Docket Nos. 50-325
and 50-324

The Commission has issued the enclosed Amendment No. 23 to Facility Operating License No. DPR-71 and Amendment No. 47 to Facility Operating License No. DPR-62 for the Brunswick Steam Electric Plant (BSEP), Unit Nos. 1 and 2, respectively. These amendments consist of changes to the operating licenses and Technical Specifications in response to your applications dated December 29, 1978, February 19, 1979, and March 6, 1979. The December 29, 1978 reload license application was supplemented by letters dated January 17, 1979, March 16 and March 27, 1979. The March 6, 1979 fire protection application was supplemented by letters dated March 7, March 15, March 22, and March 29, 1979.

UNITED STATES
NUCLEAR REGULATORY COMMISSION
WASHINGTON, D. C. 20555

SUPPLEMENT NO. 1
TO THE
FIRE PROTECTION
SAFETY EVALUATION REPORT
BY THE
OFFICE OF NUCLEAR REACTOR REGULATION
U.S. NUCLEAR REGULATORY COMMISSION
IN THE MATTER OF
CAROLINA POWER & LIGHT COMPANY
BRUNSWICK STEAM ELECTRIC PLANT
UNIT NOS. 1 and 2
DOCKET NOS. 50-325 and 50-324

FIGURE 3.2.4-1

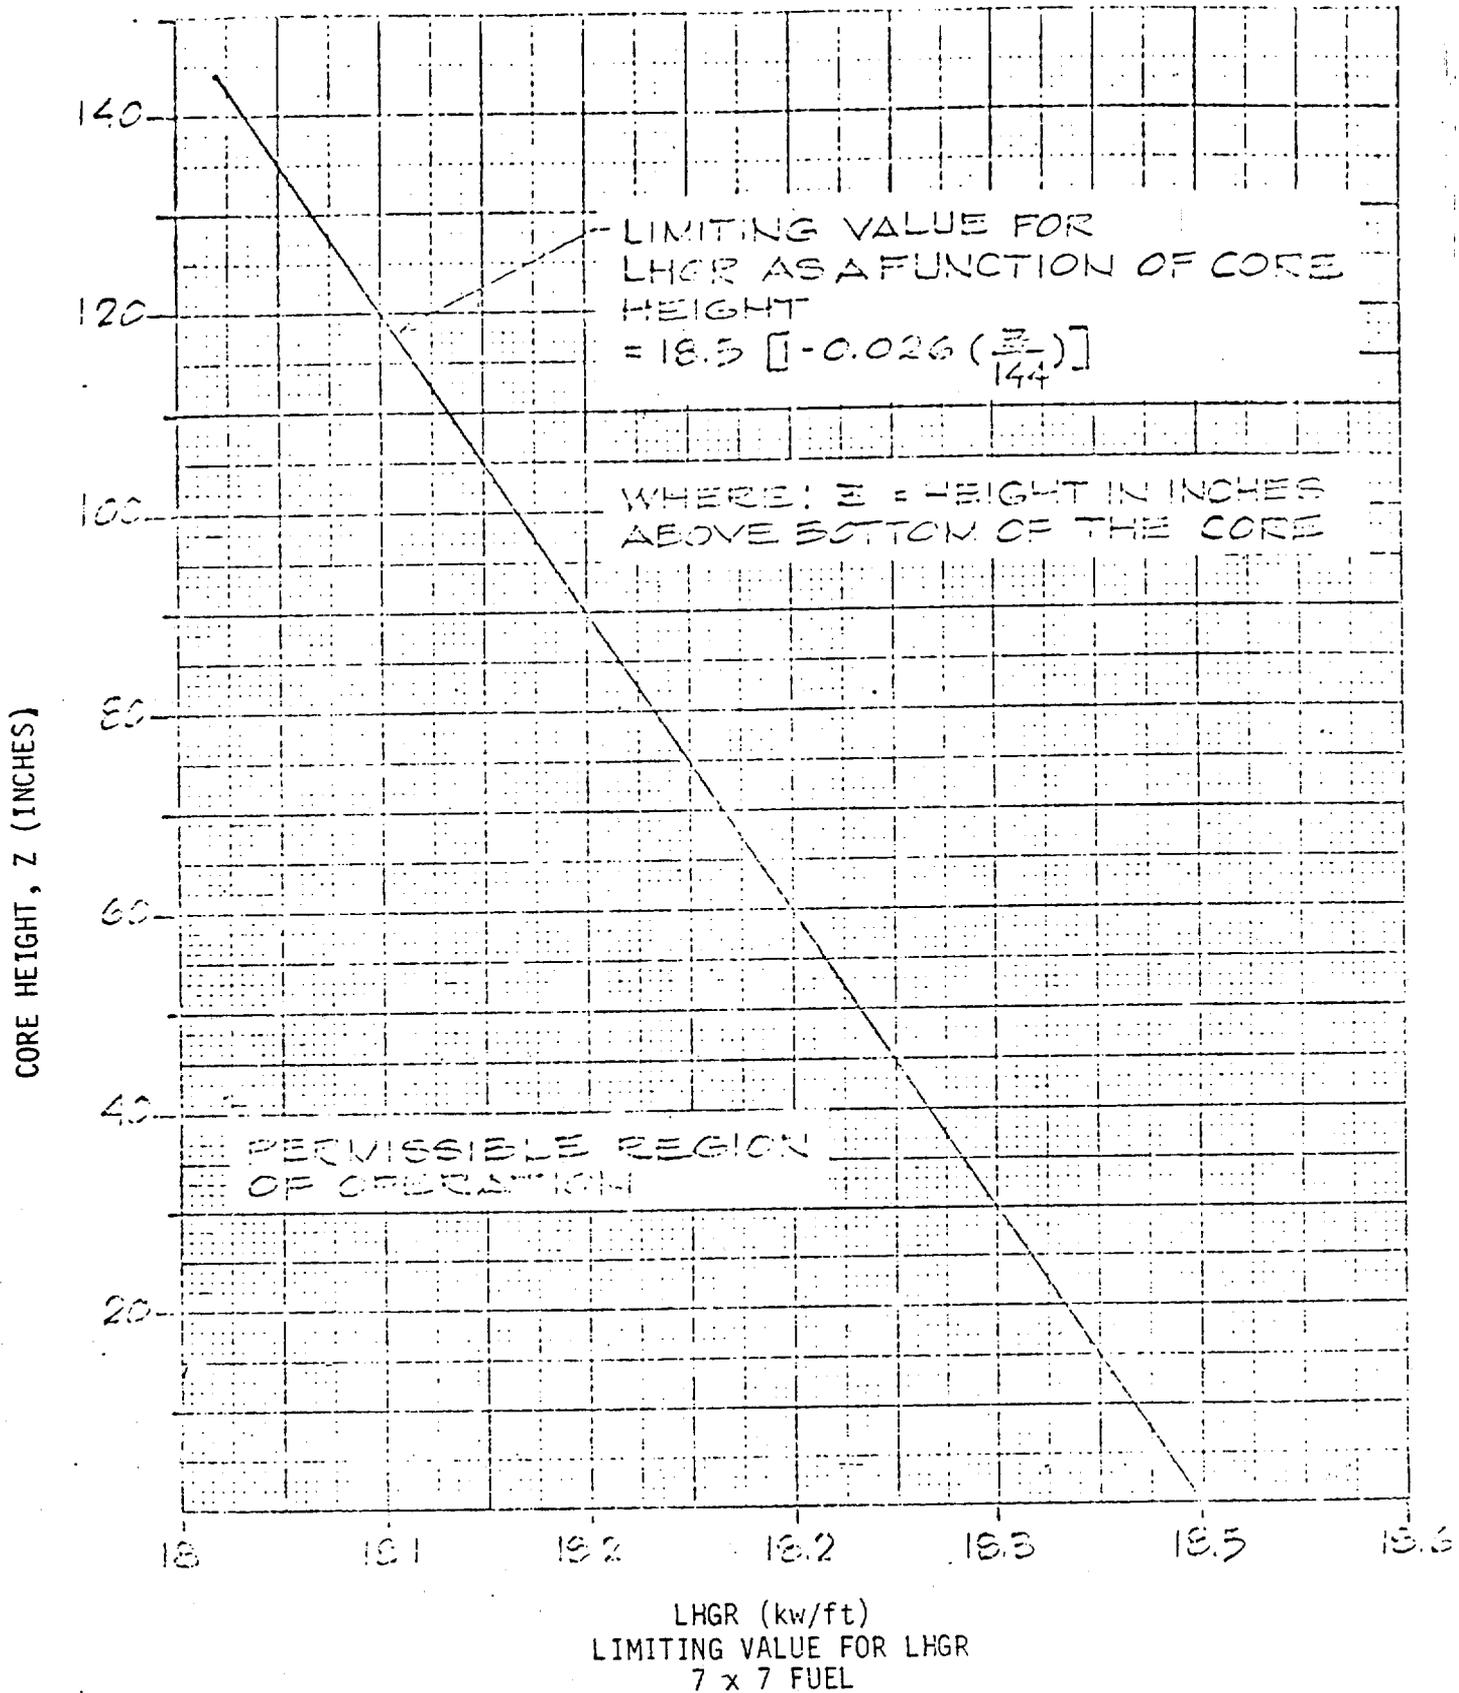
- a. For 7 X 7 fuel assemblies, as a function of core height for any fuel rod in an assembly, the maximum allowable LHGR shown in Figure 3.2.4-1.
- b. For 8 X 8 and 8 X 8R fuel assemblies, 13.4 kw/ft.
